Reference: Beaver Valley Power Station, Unit No. 1
Docket No. 50-334, License No. DPR-66
IE Bulletin 80-11

This letter forwards the additional information for IE Bulletin 80-11, "Masonry Wall Design" as requested by your letter dated March 23, 1982.

Beaver Valley Power Station - Unit 1

The following is provided as the response to the NRC request for additional information dated March 23, 1982. This report provides a reprint of each of the seven (7) staff questions with the applicable response following the question.

MASONRY WALL ANALYSIS - E 20-11 SERVICE BLDG SB 2-1

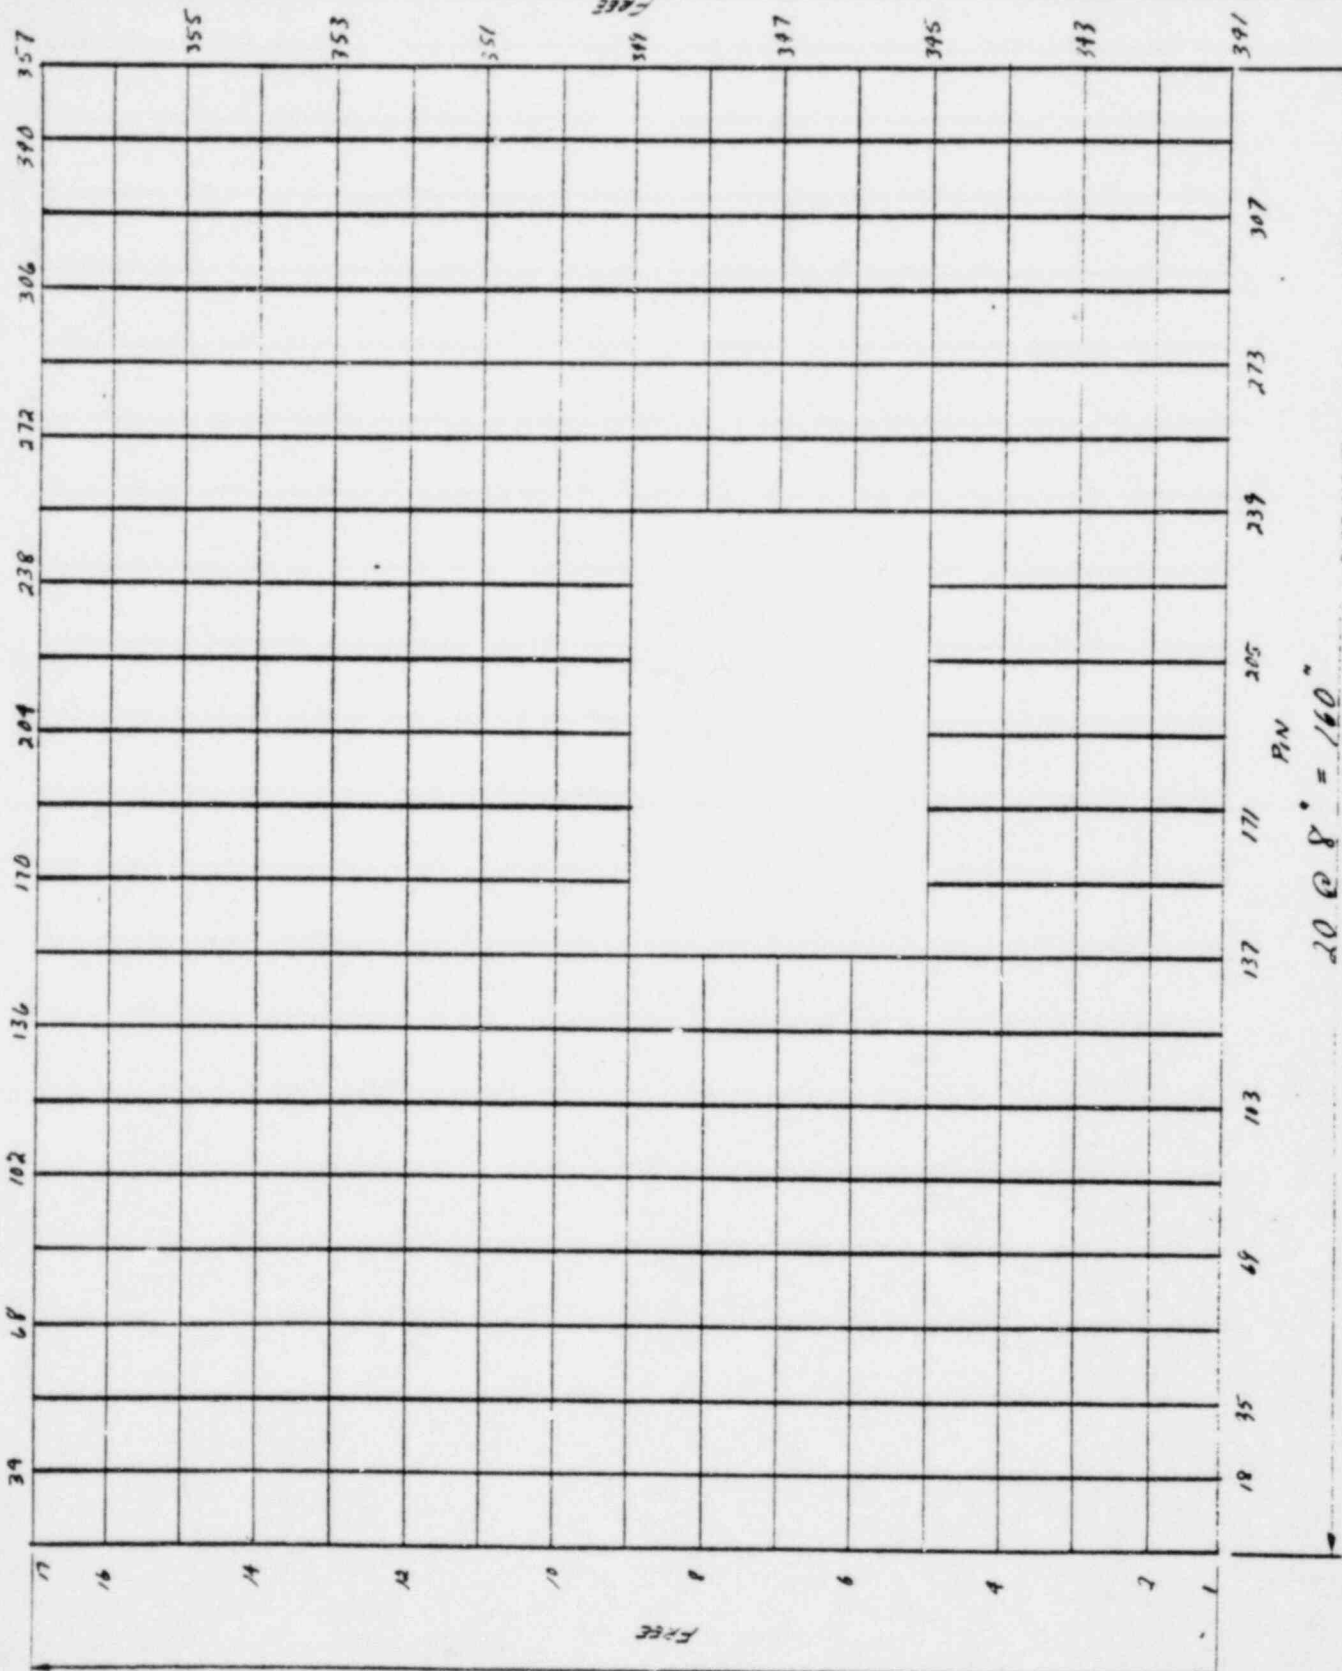
1. USING VERY CONSERVATIVE BOUNDARY CONDITIONS THE WALL WAS ANALYZED FIRST AS A UNIFILVER AND THE FREQUENCY WAS FOUND TO BE IN THE RESONANT RANGE.

2. BECAUSE OF THE OPENINGS IN THE WALL IT WAS TREATED AS A SPECIAL CASE AND REANALYZED USING FINITE ELEMENT (ANSYS).

THE BOUNDARY CONDITIONS WERE IMPROVED TO INCLUDE A PINNED SUPPORT AT THE TOP OF THE WALL DUE TO BOND AND FRICTION AT THE TOP JOINT BETWEEN THE WALL AND THE REINFORCED CONCRETE SLAB.

3. BECAUSE OF THE RELATIVELY HIGHER STIFFNESS OF THE REINFORCED CONCRETE WALL AT THE SOUTH END OF 58-2-1 THE BOUNDARY CONDITIONS WERE FURTHER IMPROVED TO INCLUDE A PINNED SUPPORT AT THAT SIDE.

NOTE: LENGTH OF BOTH WALLS ARE SAME. STIFFNESS RATIO BETⁿ CONC WALL & BLOCK WALL IS 10.12 MEANS CONC WALL IS STIFF. ALSO PER S & W STD PA-7A3, MASONRY BLOCK WALL HAS BEEN TIED WITH CONC. WALL THIS MEANS WE CAN CONSIDER ADD'L PIN SUPPORT. THEREFORE ANALYSE THIS WALL FOR THREE SDES PIN SUPPORTS.

BLOCK WALL MODIFICATION
SERVICE BLDG SHEET 1

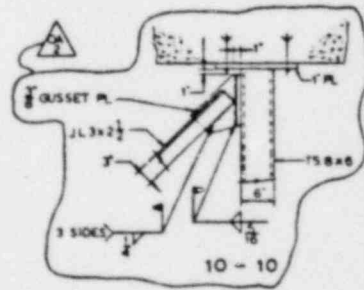
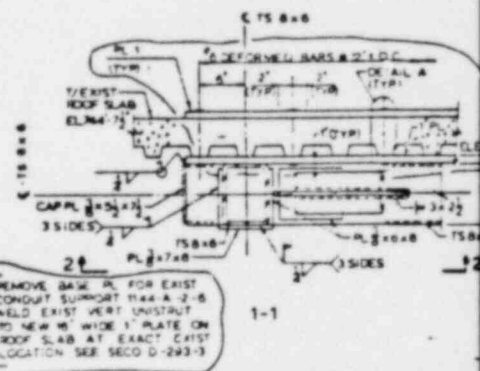
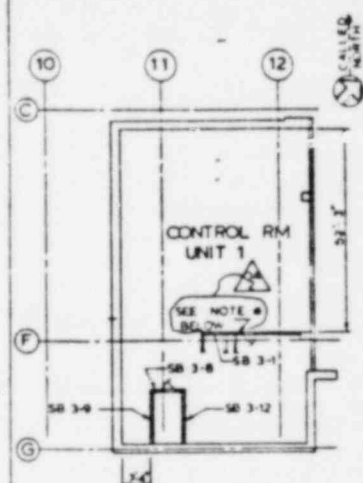
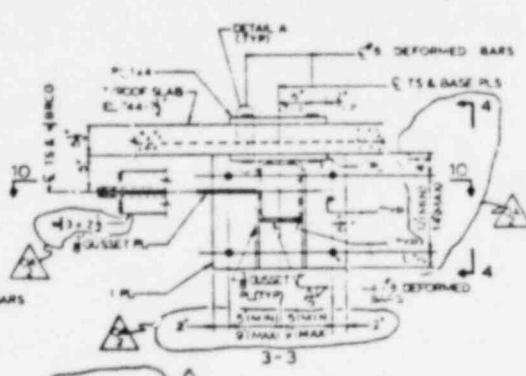
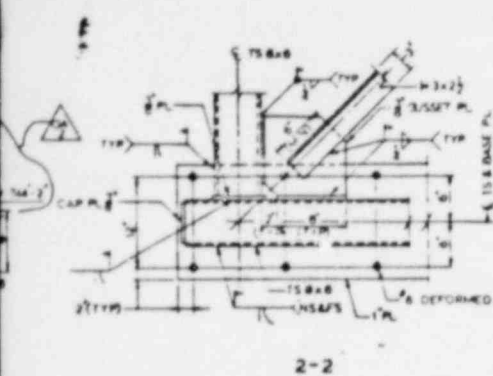
5. With reference to the proposed modification for the walls indicated in the attachment to Reference 6, provide sketches and confirmatory analysis to indicate the adequacy of these modifications.

The proposed modifications for the walls were developed in accordance with the Beaver Valley Power Station Unit No. 1 "Criteria for Re-evaluation of Concrete Masonry Walls for I & E Bulletin 80-11." The confirmatory analysis for the modifications is too voluminous to be included in this submittal, however, information is on file with the Duquesne Light Company Structural Engineering Department for review if needed.

The boundry conditions were modified as shown on the attached drawings (Attachment 5-A).

MODIFICATIONS REQUIRED FOR THE FOLLOWING BLOCK WALLS ARE SHOWN ON THIS DRAWING: SB-2-1
